Access Compliance Report

Public Rights-of-Way

Intersection ID: 31599	Main Street: TRIBUNE_DR	Cross Street: HUGUE_WY	Location: NW
ADA ID: 5EFE797D6788	Ramp Type: PerpDiag	Initial Pass/Fail: Fail	Overall Compliance: No
			Severity Score: 13.75

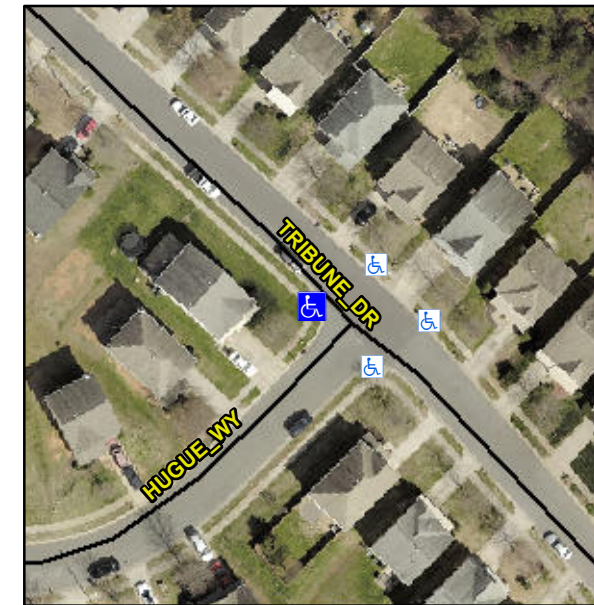
Not Found, R304.2.2, R304.5.3

Compliance	Description	Data	Compliance	Description	Data
N/A	Ramp Length (in)	49.0	No	Ramp Slope (%)	8.5
Yes	Ramp Width (in)	48.0	No	Ramp XSlope (%)	3.3
N/A	Flare Type LT	N/A	N/A	Flare Type RT	N/A
N/A	Flare Slope LT (%)	N/A	N/A	Flare Slope RT (%)	N/A
N/A	Flare Traversable LT?	N/A	N/A	Flare Traversable RT?	N/A
N/A	Landing Length (in)	N/A	N/A	DWS Provided?	N/A
N/A	Landing Width (in)	N/A	N/A	DWS Contrast?	N/A
N/A	Landing Slope (%)	N/A	N/A	DWS Length (in)	N/A
N/A	Landing X Slope (%)	N/A	N/A	DWS Full Width?	N/A
N/A	Landing Curb? (Y/N)	N/A	N/A	DWS Offset (in)	N/A
N/A	Shared Landing?	N/A			
N/A	Gutter Ponding?	N/A	N/A	Gutter Slope (%)	N/A
N/A	Gutter Lip Ht (in)	N/A	N/A	Gutter X Slope (%)	N/A
N/A	Painted X Walk1?	No	N/A	Painted X Walk2?	No
	X Walk 1 Direction	To SE		X Walk 2 Direction	To NE
N/A	X Walk 1 Width (in)	N/A	N/A	X Walk 2 Width (in)	N/A
	X Walk 1 Slope (%)	0.1		X Walk 2 Slope (%)	3.8
	X Walk 1 X Slope (%)	4.0		X Walk 2 X Slope (%)	1.1

Remove & Replace Curb Ramp With Two New Directional Ramps or Equivalent.
